TO: Freightliner Dealer Principals, General Managers, Sales Managers, Service Managers, Parts Managers	FROM: Anthony Washington, Senior Manager, Regulations and Certifications
Re: Launch Recall Campaign Notification Model: Sprinter (907) Model Years: 2019-2021 Replace eCall Communication Module	DATE: April, 2024

Campaign No. :	Campaign Desc. :	Replace eCall Communication Module
2024030013	VS3SIMKOW	
This is to notify you of a Recall Campaign launch to replace eCall communication module on approximately 137 MY 2019-2021 Freightliner Sprinter Vans. The recall campaign will be visible on the www.safercar.gov website and may generate questions from customers. All affected VINs will be flagged as "OPEN" in VMI and cannot be sold until remedied.		
Background		
Issue	Mercedes-Benz AG ("MBAG"), the manufacturer of Freightliner Sprinter vans, has determined that due to an interaction between a SIM card security mechanism and the affected SIM profile, the SIM card might inadvertently become disabled. Should this occur, the communication module would not be able to establish a connection with a mobile phone network. In this case, the eCall function would not be available. Therefore, the cond

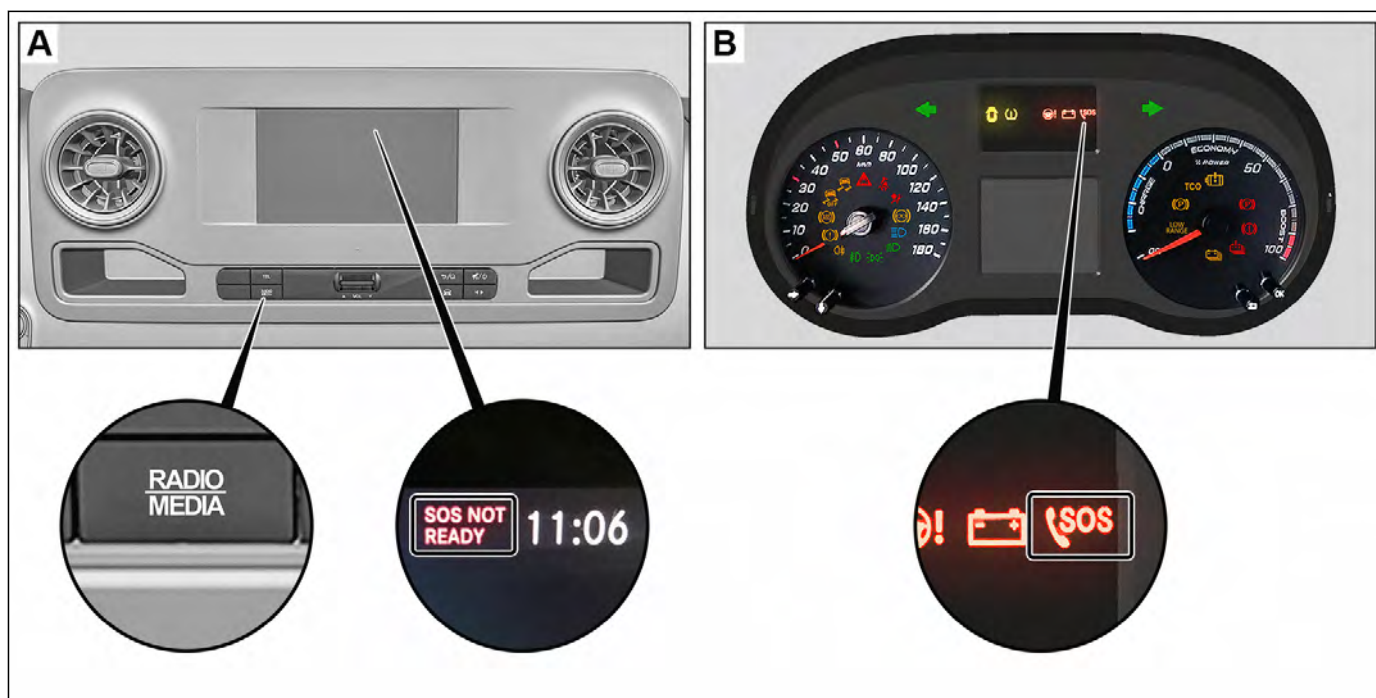
8.1	Perform function test of emergency call system.	Model 907 with code E3M (MBUX multimedia system with 7-inch touchscreen) or code E4M (MBUX multimedia system with 10.25-inch touchscreen)  See Fig. A.  To do so, press start button once, without touching brake pedal, to switch ignition to position 1. Then set head unit to radio menu and check whether "SOS-NOT READY" appears in display. Press start button a second time, without touching brake pedal, to switch ignition to position 2. Check whether "SOS-NOT READY" disappears automatically in display.

8.2	Perform function test of emergency call system.	Model 907 except code E3M (MBUX multimedia system with 7-inch touchscreen) except code E4M (MBUX multimedia system with 10.25-inch touchscreen)  See Fig. B.  To do so, press start button twice, without touching brake pedal, to switch ignition to position 2. Check whether "SOS" warning lamp in instrument cluster goes out automatically.	
	Remove		
9 	Remove vehicle diagnosis system.		AD00.00-D-2000-06TS
10 	Remove the 12 V charger from vehicle.		AR54.10-D-1127TS
